Navajo Nation
Through Its Department of Water Resources Water Management Branch
October 22, 2021

SUBJECT: ADDENDUM #1 NOTICE

Let this memorandum serve as a notice of additional information regarding the **“Contract No. 2: Bodaway-Gap Well House No. 3 Construction, Storage Tank No. 2, Altitude Valve, and Pipelines Navajo Nation Bid Number 21-09-2581LE”**.

4" x 2" P.R.V.

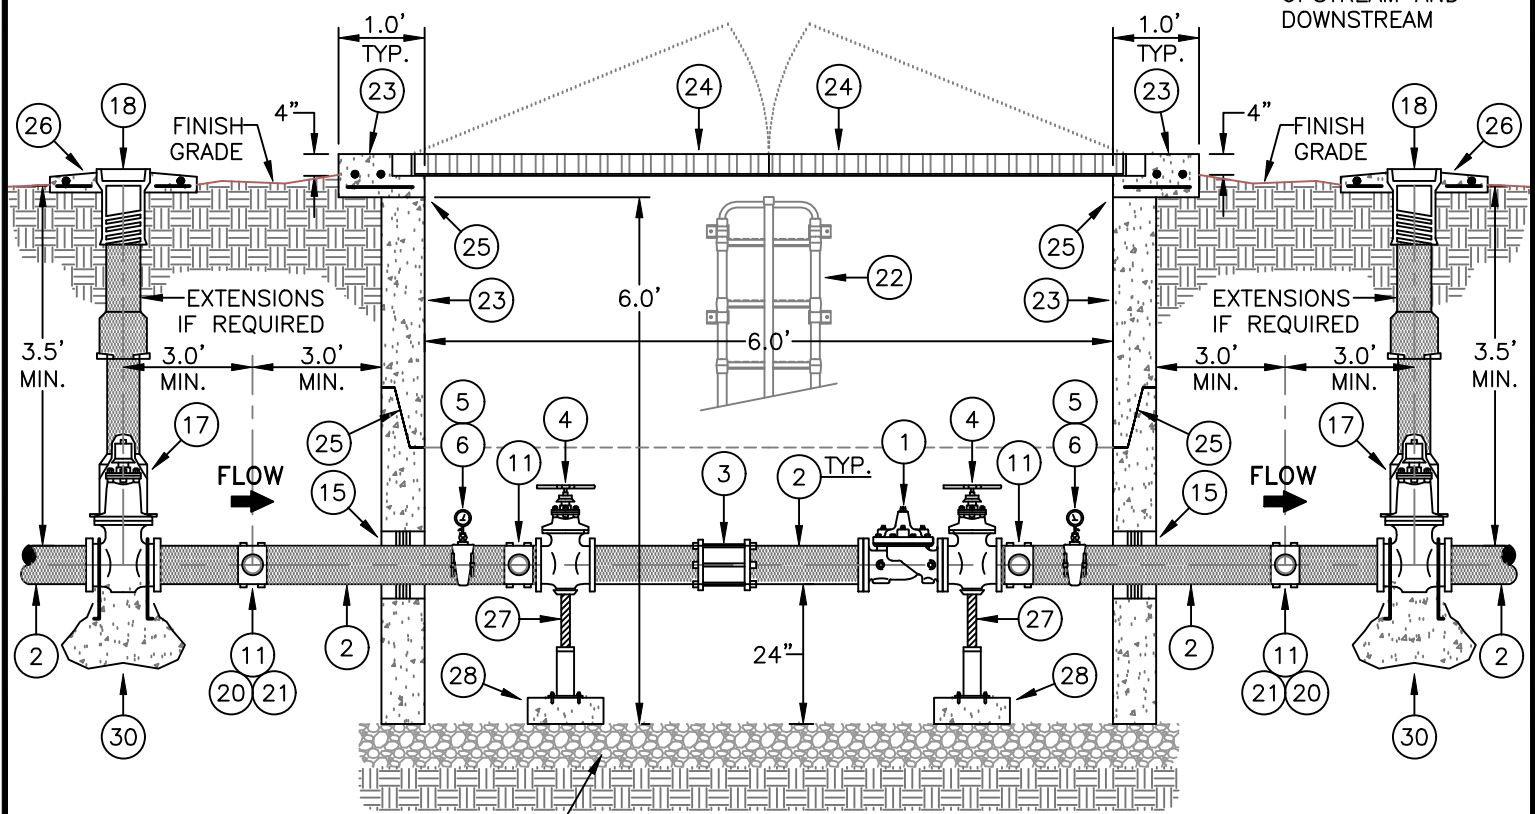
1. In reference to the drawings for the “Western Navajo Pipeline Phase 1 Bodaway-Gap Well, Tank, and Pipeline Project, October 2021, Bid Issue”, the altitude vault page C-120 notes for “Revisions to HIS STD DWG W-28”, notes 4-7, and 10, 11 refer to a drawing that is not included in this plan set. The notes reference **NTUA Standard 4”x2” PRV Detail** which is not included in the NTUA drawings section.

Answer: The notes on sheet C-120 do refer to the NTUA Standard 4”x2” PRV detail. The two drawings WS-4b and WS-4b, which are the NTUA Standard 4”x2” PRV detail, were mistakenly left out of the plan set. The Index sheet has been updated and these two drawings are included as an attachment with this addendum.
